18 December 2014

**SSD5093 – North Ryde Station Precinct “M2 Site”  
Response to Transport for NSW Submission**

## Review of TfNSW Spine Road Lane Width Recommendation

FIGURE 1 – BUS ZONE ON PARK STREET (SOURCE: DRAWING C-0-5-0-4, ROBERT BIRD GROUP)

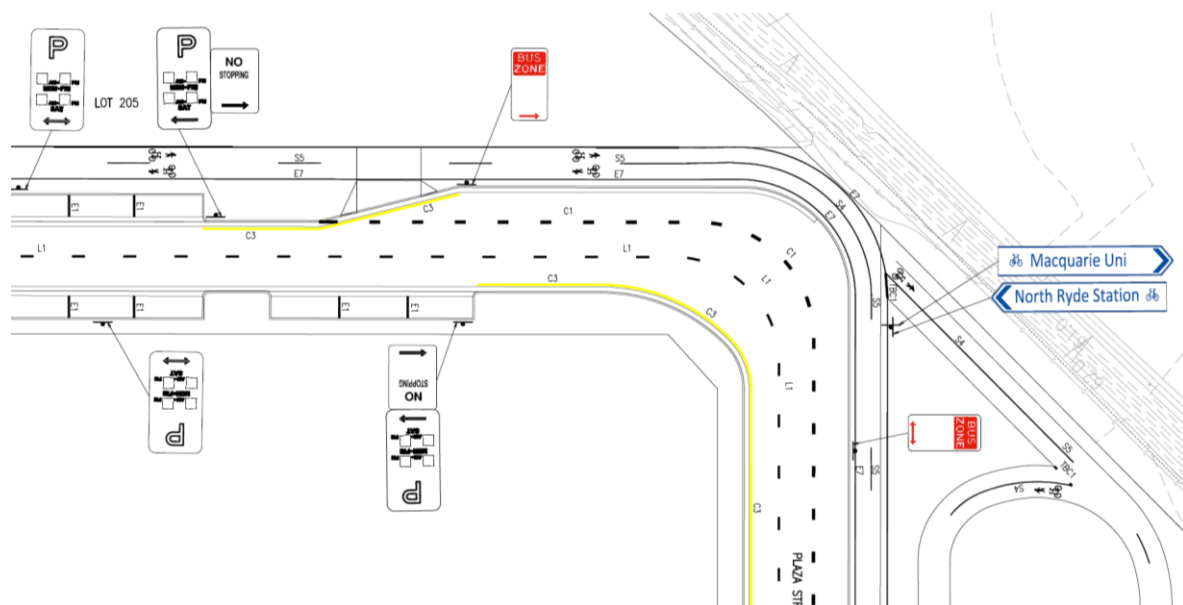
TfNSW requests written confirmation and an updated diagram that confirms that the three bus bays in the retail precinct are capable of accommodating an articulated vehicle. Signs and Line Marking Drawing C-0-5-0-4 prepared by Robert Bird Group submitted with the Response to Submissions shows the bus zone sign and line marking proposed on Park Street. Refer to drawing extract at Figure 1.

It is confirmed that the three bus bays provided in the retail precinct on Park Street and Plaza Street are designed to accommodate articulated buses and appropriate signs and line marking were provided on the civil drawings that accompanied the Proponent's Response to Submissions report.

- **STA BIG Section 5.2**

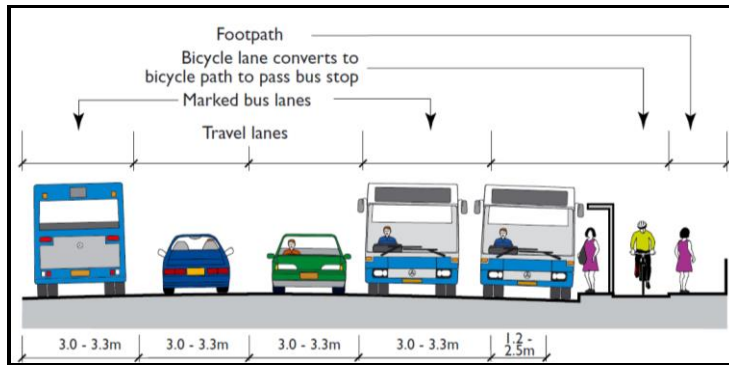
As referenced in the Section 6.3 of the NRSP TMAP (above), the recommended increase in lane width from 3.0m (under the Ryde DCP) to 3.25m (under the NRSP DCP) references Section 5.2 of the STA BIG, which provides the following: -

*The minimum desirable lane width for bus routes is 3.2m.*

- **SSDA *Plan C-0-3- 40 Swept Path Analysis Plan Sheet 1 of 2***

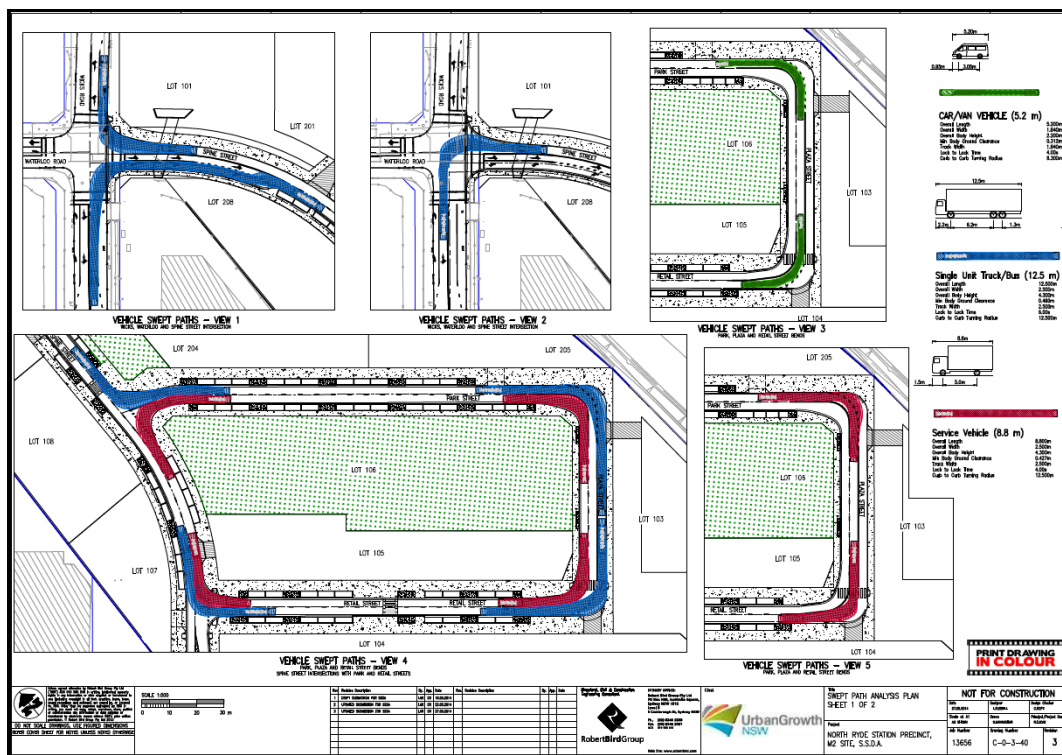
Notwithstanding the above – and with specific reference to the TfNSW *Recommendation* - the movement of an articulated bus through the M2 Site was also assessed as part of the SSDA process, and it has been determined that an articulated bus – which critically again is not the design vehicle with reference to the STA BIG Section 2.3 – can move through the M2 Site with relatively minimal lane sharing.

Many of the key turning movements shown in the SSDA *Plan C-0-3- 40 Swept Path Analysis Plan Sheet 1 of 2* required design changes to specifically facilitate these 12.5m bus template turning paths, including 'flattening' kerb radii at key locations, but nonetheless the M2 Site – and specifically the Spine Road - provides for the movement of 12.5m buses with a turning radius of 12.5m as per the requirements of the STA BIG; and utilising 3.25m lane widths as per the requirements of the NRSP TMAP, the NRSP DCP, the STA BIG and the RTA RDG.

However - and critically - the analysis of the articulated bus movements also shows that lane sharing by an articulated bus would occur regardless of the width of the lanes, i.e. there would be no significant difference between the lane sharing to/from a Spine Road with lane widths of 3.25m, or a Spine Road with lane widths of 3.5m.
